ELSA 5th meeting, January 22./23., 2009

ELECTRICAL SAFETY PROVISIONS FOR VEHICLES IN USE

OICA proposal / JAMA proposal

Figure 1: Measurement of V_b , V_1 , V_2

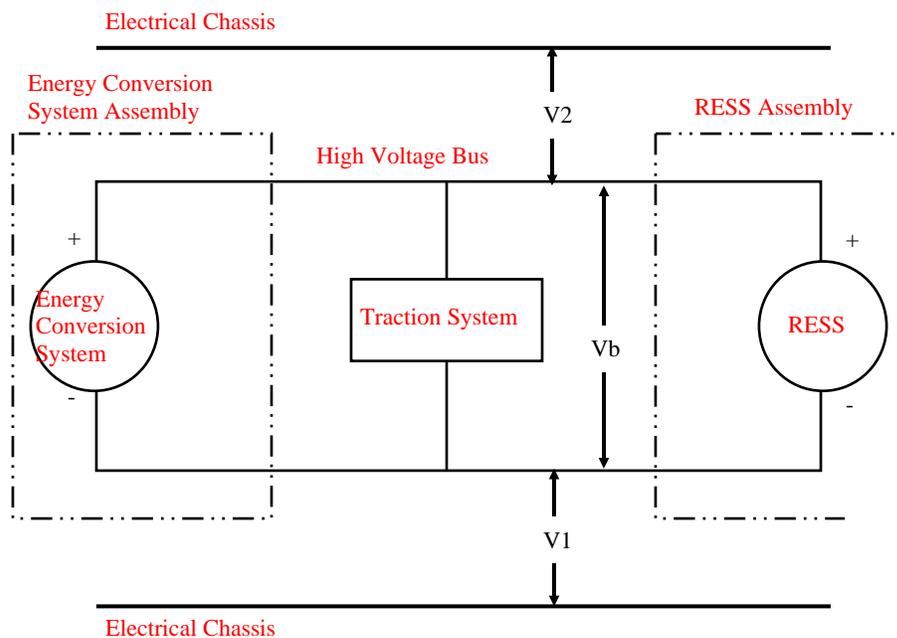
The voltage is measured as shown in Figure 1 and the high voltage Bus voltage (V_b) is recorded. V_b shall be **must be** equal to or greater than the nominal operating voltage **of the RESS and/or energy conversion system** as specified by the vehicle manufacturer.

Measure and record the voltage (V_1) between the negative side of the high voltage bus and the electrical chassis (see Figure 1):

Measure and record the voltage (V_2) between the positive side of the high voltage bus and the electrical chassis (see Figure 1):

Figure 2: Measurement of V_1'

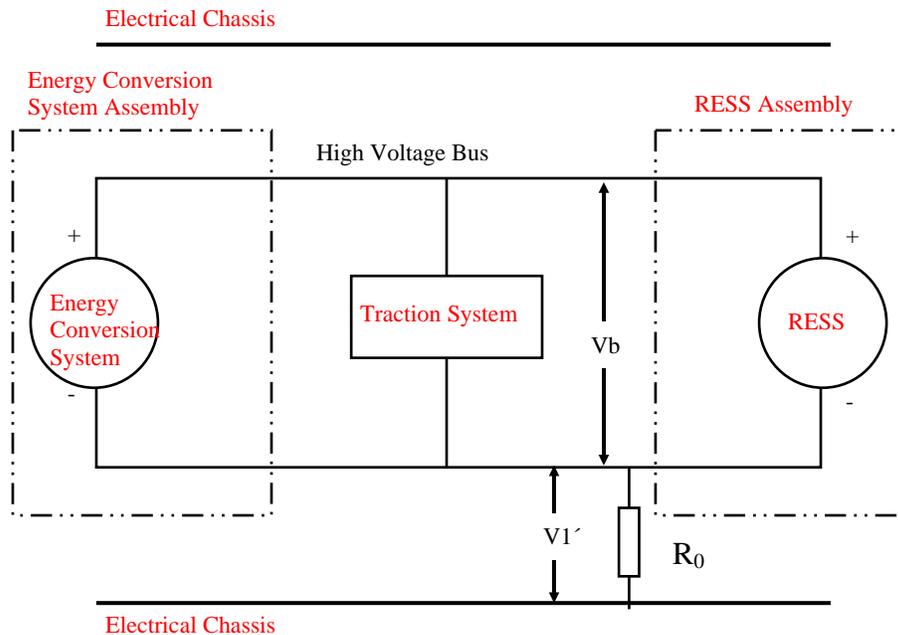
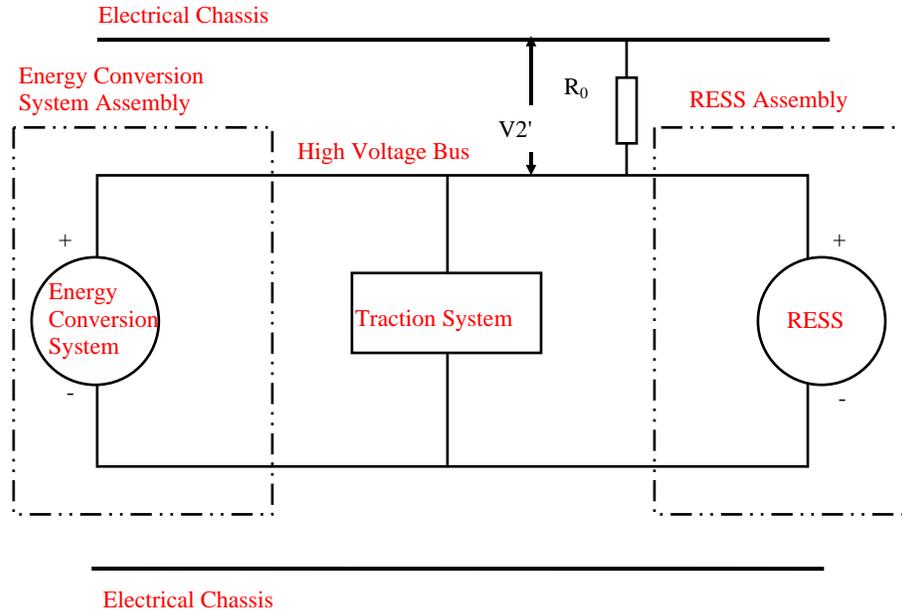
If V_1 is greater than or equal to V_2 , insert a standard known resistance (R_0) between the negative side of the high voltage bus and the electrical chassis. With R_0 installed, measure the voltage (V_1') between the negative side of the high voltage bus and the electrical chassis (see Figure 2).

Calculate the electrical isolation (R_i) according to the following formula:

$$R_i = R_0 * (V_b / V_1' - V_b / V_1) \quad \text{or} \quad R_i = R_0 * V_b * (1 / V_1' - 1 / V_1)$$
